Determination 2011/102

Compliance of a proposed pebble strip to a house at 2/35A Wheturangi Road, Greenlane, Auckland

Applicant: C Connor (“the owner”)
The authority: Auckland Council (“the authority”)

2.2 The existing drainage channel extends between pebble beds as shown in Figure 1.

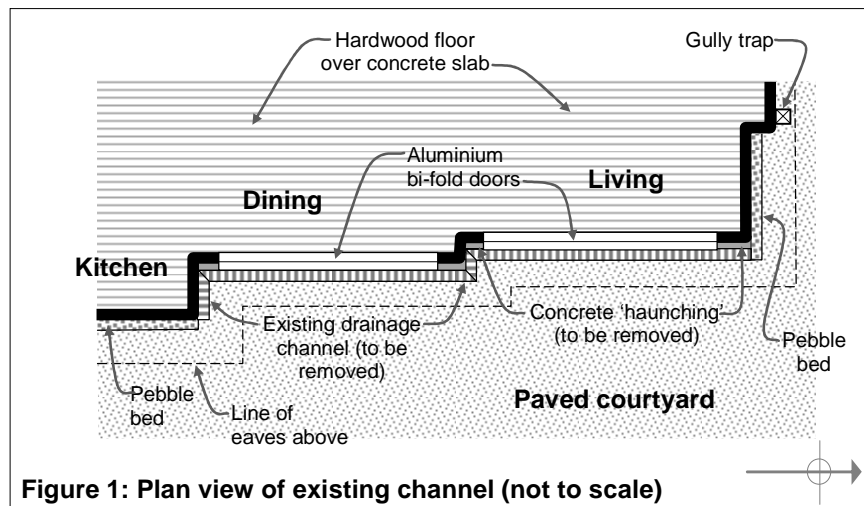
- A concrete ledge or haunching, separates the channel drain from the wall; impeding free drainage of water from the cladding and cavity into the drain.
- Lack of clearance to concrete haunching can allow moisture movement into the cladding and cavity via accumulation of debris on the ledge, which also prevents maintenance of lower edges of weatherboards and the door sill.
- The timber sill is effectively in contact with the ground.
- The details as built are likely to require much more than normal maintenance to prevent moisture and debris build up in the bottom of the wall cavity.

- 4.2.1 In a letter to the Department dated 31 October 2011, the authority referred to concerns raised about the channel drain in its submission for the first determination and stated that it has 'the same concerns with the pebble area as we do with the unpebbled channel drain'. The authority listed those concerns as follows:

B2 – Durability is applicable to everything, therefore, concerns with durability of timber framing (bottom plate being close to the ground) weatherboards being in close proximity to the ground, bottom plate connections, nails etc too close to the ground.

5.4 The expert concluded that the existing pebble beds are performing satisfactorily and therefore provide reasonable evidence that replacing the existing channel drain with a similar arrangement is likely to provide a weathertight and durable solution.

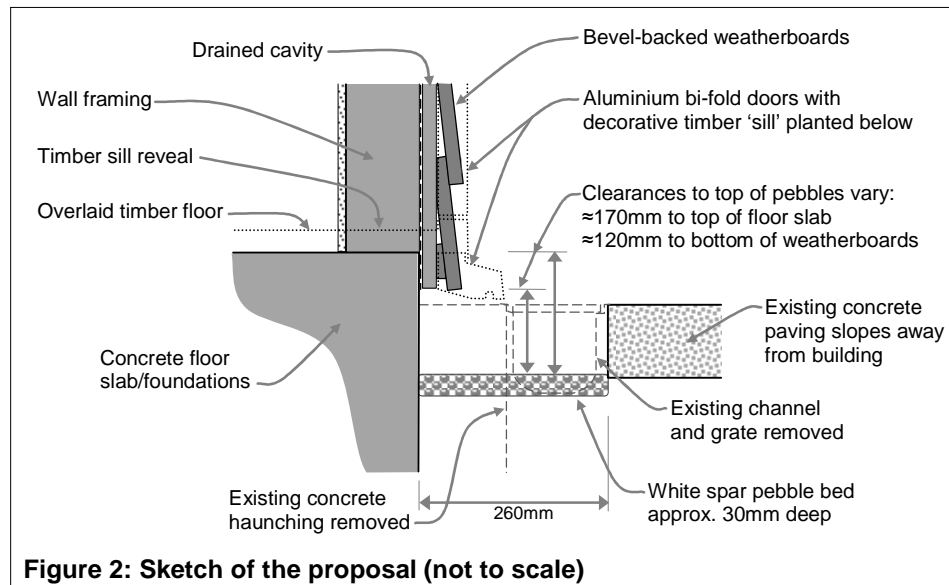
- 3.4 In an email to the applicant dated 29 September 2011, the authority stated:
- ...the proposed alternative solution you submitted for consideration has been rejected with concerns over how the bottom plate and its fixings will be protected from potential moisture damage.

- 6.6.1 The proposal is also required to comply with the requirements of Clause D1 Access Routes, which includes the requirement to provide 'safe and easy movement' through doorways. Because the proposed pebble bed will cross doorways and create a tripping hazard, the proposal does not comply with Clause D1.
- 6.6.2 However, satisfactory resolution of this hazard, for example in the form of a removable grating, will result in the proposal being brought into compliance with Clause D1 of the Building Code.

- The proposal addresses the channel drain defects identified in the first determination (refer paragraph 3.2.1) by
 - removing the concrete haunching to allow free drainage from the cladding and cavity into the proposed pebble bed

- providing adequate clearance below the weatherboards and sill to prevent moisture movement into the timber
 - allowing sufficient space for clearing debris and maintaining the underside of the weatherboards and sill.

6.4 Taking the above into account, I have reasonable grounds to be satisfied that the existing pebble beds and the proposed extension of these to replace the existing channel drain comply with Clauses B2 and E2 of the Building Code.
